REF: 1774/MR/Queries/mjs

RE: MANLEY ROAD, WREXHAM: PLANNING REFERENCE WRC P/2014/0585

FIGURE 2

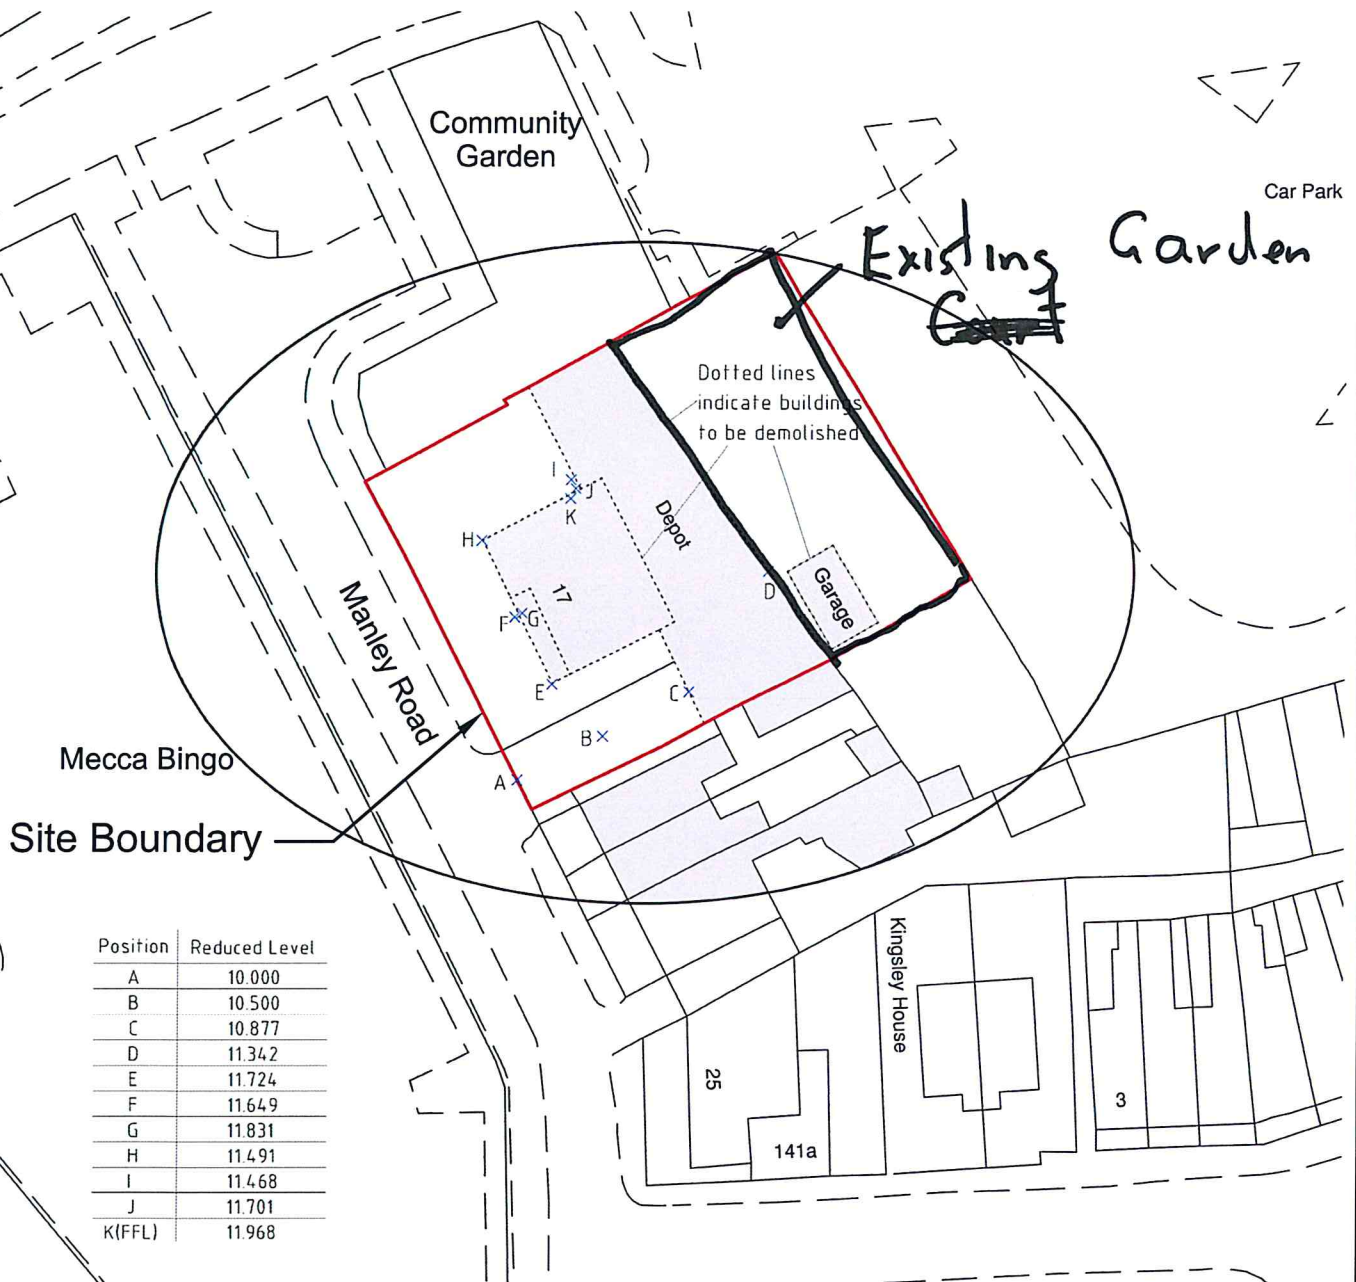
To clarify the garden issue figure 2 attached shows the existing garden, and Figure 4 shows half of this area being converted to car parking. To achieve this it will be necessary to remove the topsoil and construction of the car parking will take place directly off the sand and gravel.

It is not intended to test the topsoil/made ground any further, as this has been confirmed to have lead contamination. It is only intended to test the underlying natural sand and gravel to confirm that the lead contamination does not extend to this horizon before placing the imported topsoil, which will be tested.

We can therefore confirm that the original remediation strategy still stands and the best time to take the additional samples is when there is a machine on site during the demolition, as the pits to date were hand excavated.
